SERVICE BULLETIN

Nov. 25, 2014

#3 Piston Clamp Pump

533012- Piston Clamp Pump AA2FM16/61W-VSC530

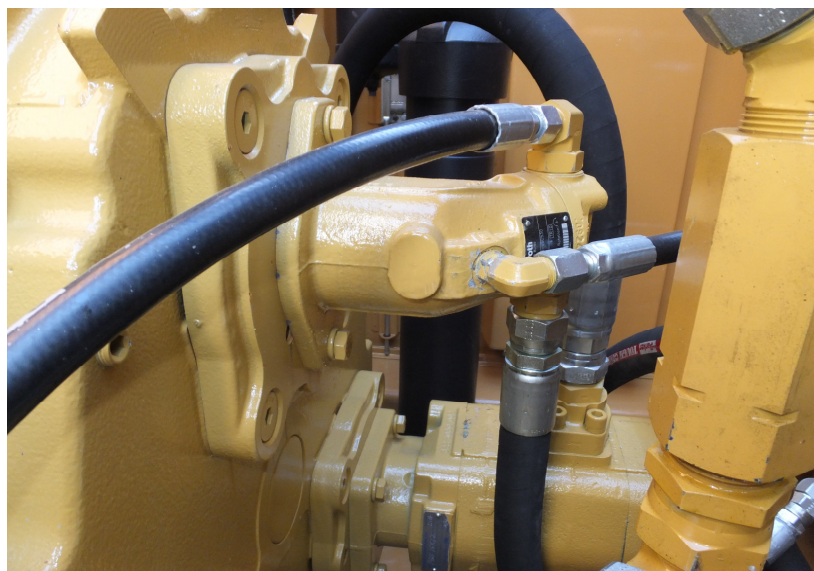
The gear pump that we have used for many years has been upgraded to a bent axis piston pump. This is a direct replacement pump that will allow full clamp pressure to be achieved within the pumps high pressure rating. Piston pumps also run cleaner, generating fewer particulates, meaning less contamination in the hydraulic system. Port sizes are the same as the clamp gear pumps that were on power units manufactured before June 2014. The fittings and hoses can be reused when a retro fit is completed, with the addition of a case drain line to tank.
